City of Puyallup - Downtown Puyallup Gateway and Wayfinding Signage

PRROW20260770

PRROW20260770 shall only be for geotech boring and potholing. All other design elements are for reference only.

Figure 1. Approximate Traffic Control Zone - Site Plan (North)

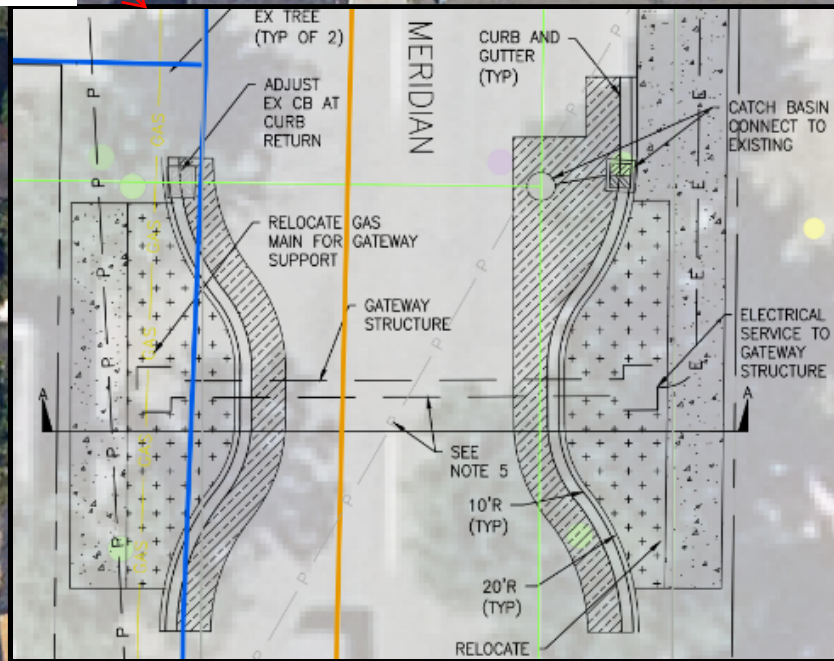
Any public facilities, i.e. utilities, curb, gutter, driveway approach, curb ramp, sidewalk, etc., broken now or during the course of construction shall be removed and replaced to current City Standard. Restoration limits and requirements shall be at the discretion of the City.

A 10" diameter core drill is allowed for potholing. For pothole windows larger than 10" in diameter or trenching completed in existing roadway, the contractor shall restore the pavement by installing the trench patch and then grinding/overlaying. All roadway restoration and street patches shall comply with City Standard Detail 01.01.20.

Figure 2. Approximate Traffic Control Zone - Site Plan (South)

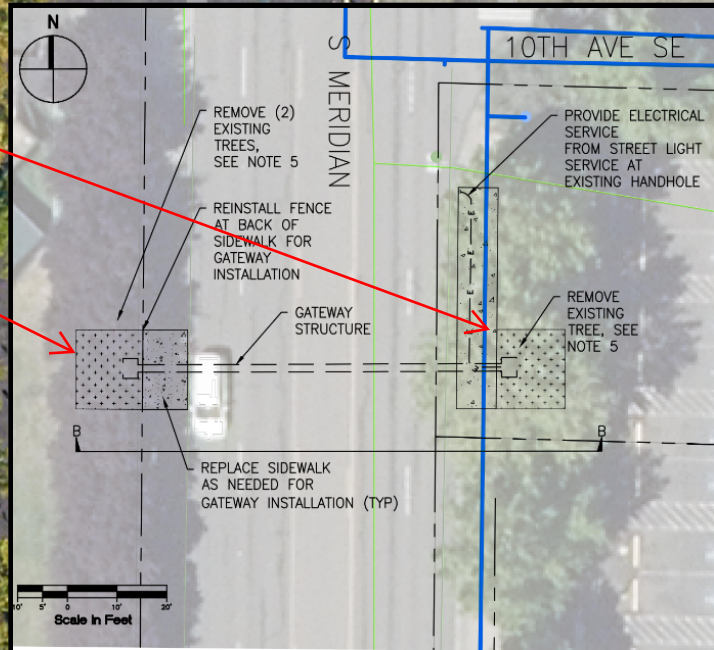
Any public facilities, i.e. utilities, curb, gutter, driveway approach, curb ramp, sidewalk, etc., broken now or during the course of construction shall be removed and replaced to current City Standard. Restoration limits and requirements shall be at the discretion of the City.

A 10" diameter core drill is allowed for potholing. For pothole windows larger than 10" in diameter or trenching completed in existing roadway, the contractor shall restore the pavement by installing the trench patch and then grinding/overlaying. All roadway restoration and street patches shall comply with City Standard Detail 01.01.20.

PRROW20260770 shall only be for geotech boring and potholing. All other design elements are for reference only.

FIGURE 1 - POTHOLE AND UTILITY PLAN (NORTH)

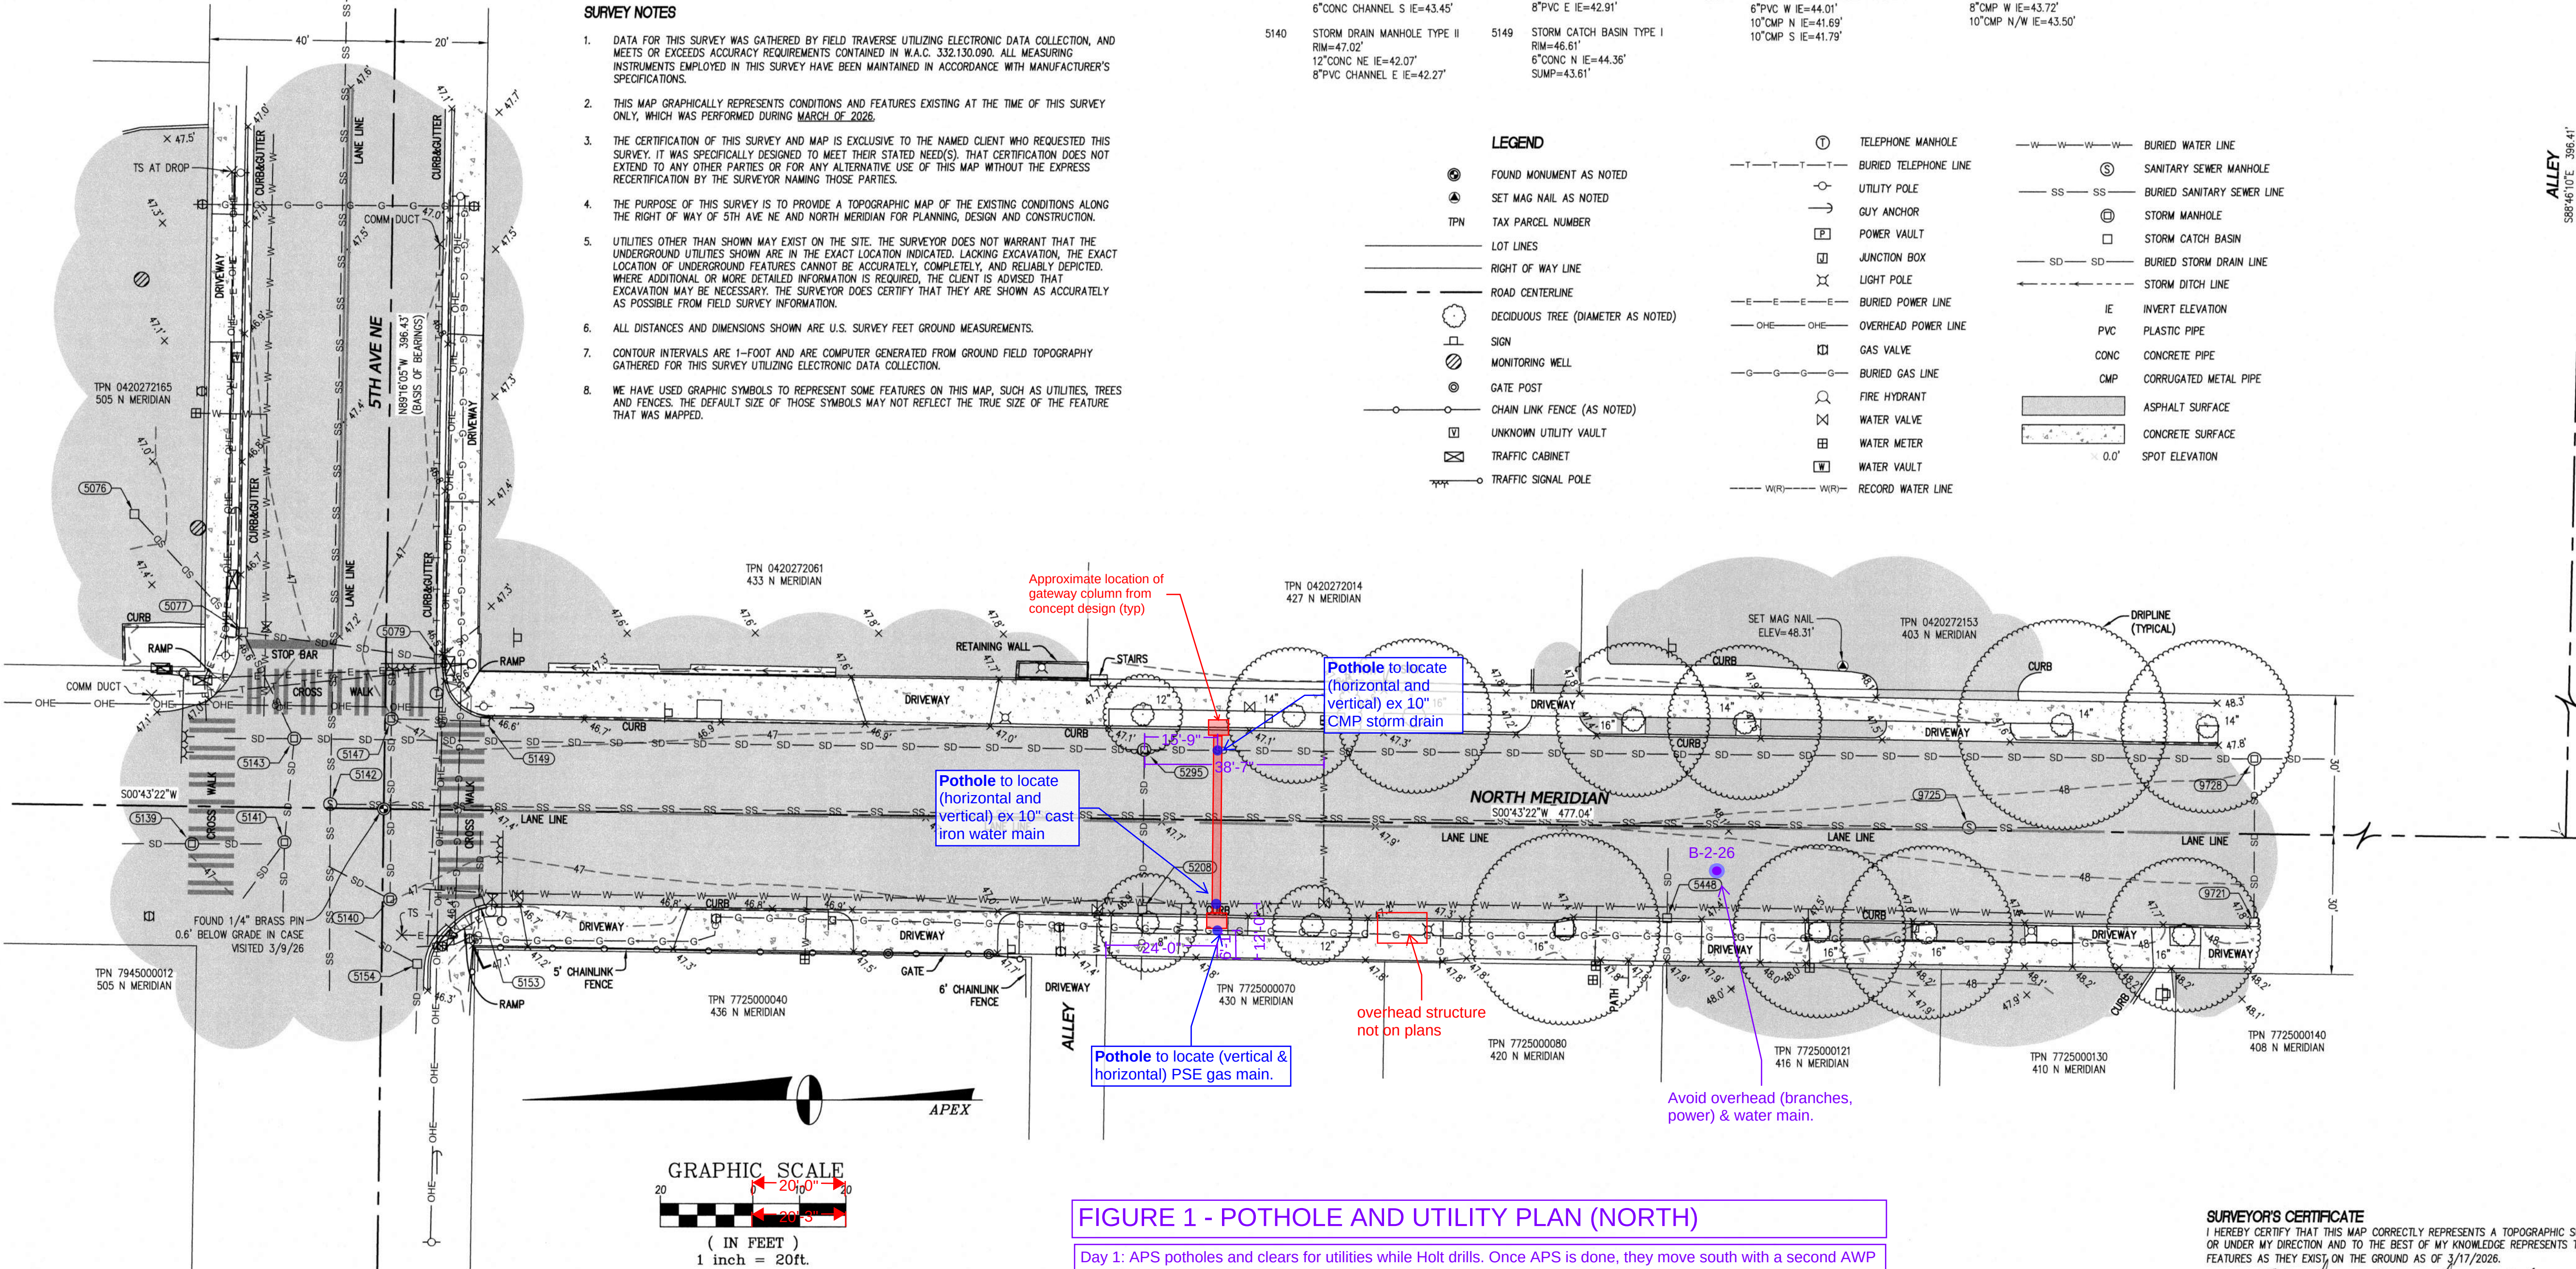
Any public facilities, i.e. utilities, curb, gutter, driveway approach, curb ramp, sidewalk, etc., broken now or during the course of construction shall be removed and replaced to current City Standard. Restoration limits and requirements shall be at the discretion of the City.

A 10" diameter core drill is allowed for potholing. For pothole windows larger than 10" in diameter or trenching completed in existing roadway, the contractor shall restore the pavement by installing the trench patch and then grinding/overlaying. All roadway restoration and street patches shall comply with City Standard Detail 01.01.20.

PRROW20260770 shall only be for geotech boring and potholing. All other design elements are for reference only.
